ADDENDUM NUMBER 2

MARCUS CENTER FOR THE  
PERFORMING ARTS  
WEST PLAZA PAVING RENOVATION  
Site #270, Bldg. #50  
929 North Water Street  
Milwaukee, Wisconsin

Project Number: O508-10610

Date of Addendum: April 22, 2011

A02-02

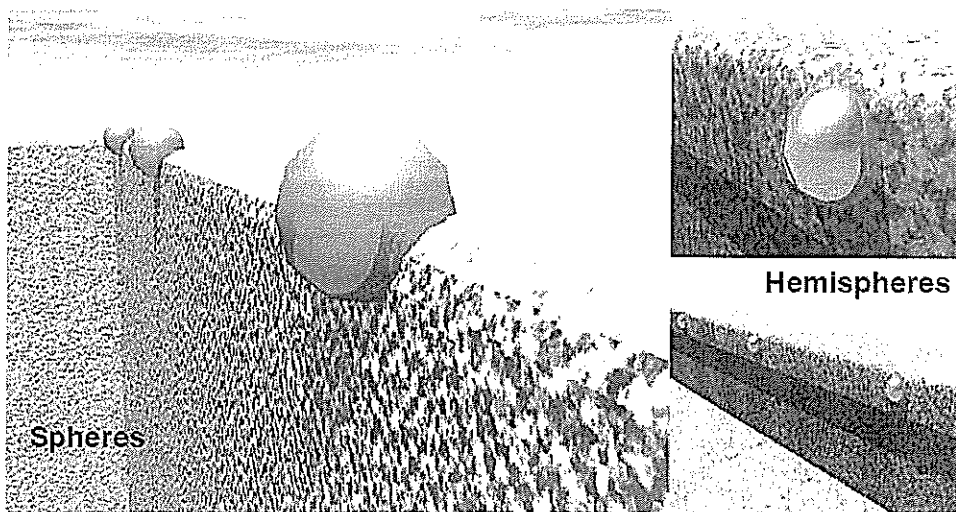
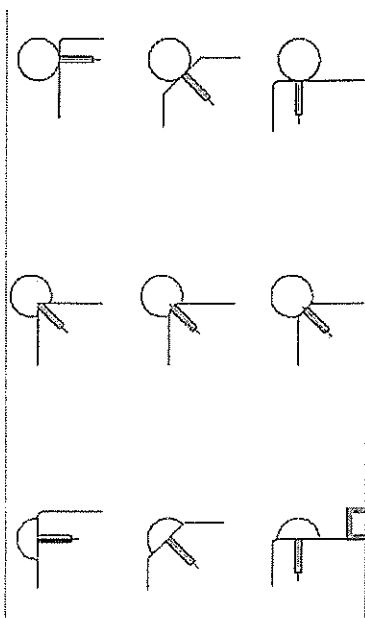
**6. Source for Skateboard Guards located at Concrete Walls per Detail found within Dwg. 01/A2.0**

- URBANFAB Street Products  
www.urbanfab.com  
(see also attached Specification Cut Sheet labeled A02-02)

**A02-03**

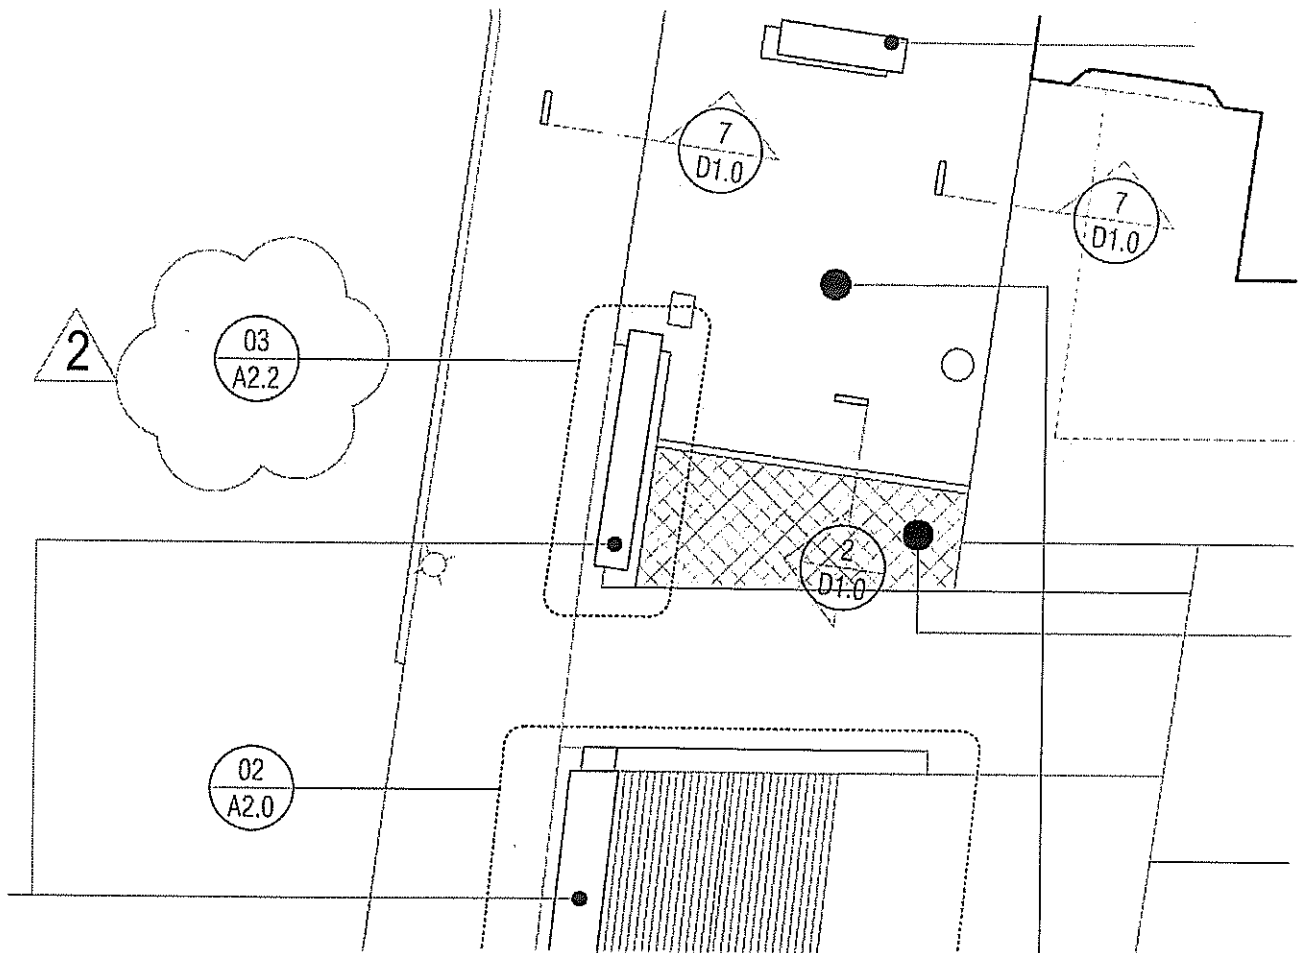
**7. Clarification on Detail Call-Out on Drawing A1.0 within CD Set.**

A1.0 - Site Plan (Call Out Clarification @ Edge Bench)

- See attached Drawing labeled A02-03 for clarification
